INFORMATION RECEIVED SINCE PREPARATION OF REPORT

Application number	TWC/2017/0643
Site address	Land to the North of Haygate Road, Wellington, Telford, Shropshire
Proposal	Reserved matters application for the erection of 289no. dwelling including details for appearance, landscaping, layout and scale pursuant to outline application TWC/2013/1033
Recommendation	Reserved Matters Grant

Figure 2: Woodlands Avenue Sub-catchment Post Development

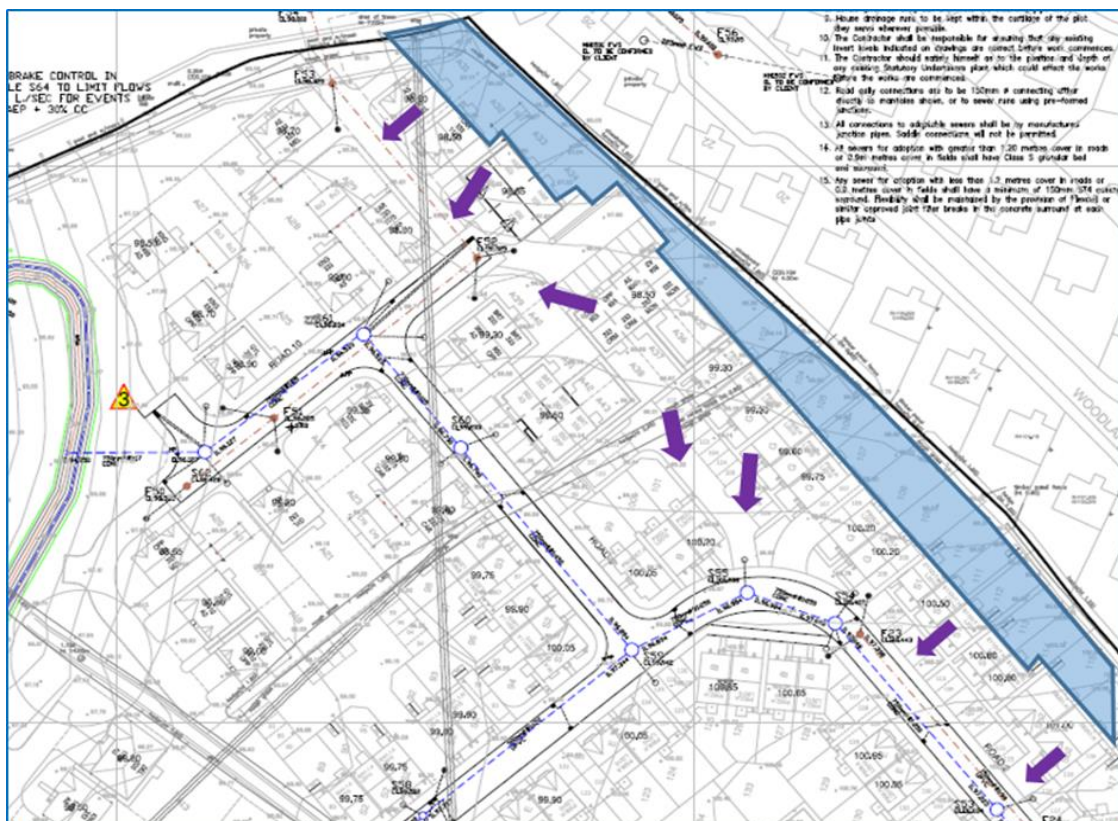
1.4.3 It is difficult to understand how the Drainage Officer has deduced the reduction in the size of the area of land draining towards the Woodlands Avenue boundary given that no detailed drainage scheme has been proposed yet.

2.3 The reduction in drainage area referred to by Drainage Officers has been calculated based upon the areas of hard surfacing shown on the site layout plans. Whilst a detailed drainage scheme for this part of the site has not been provided, the reduced sub-catchment area to which they refer is the soft landscaped/grassed area between the hard surfacing and the boundary. This is clearly shown in the Drainage Officer's comments (shown below).
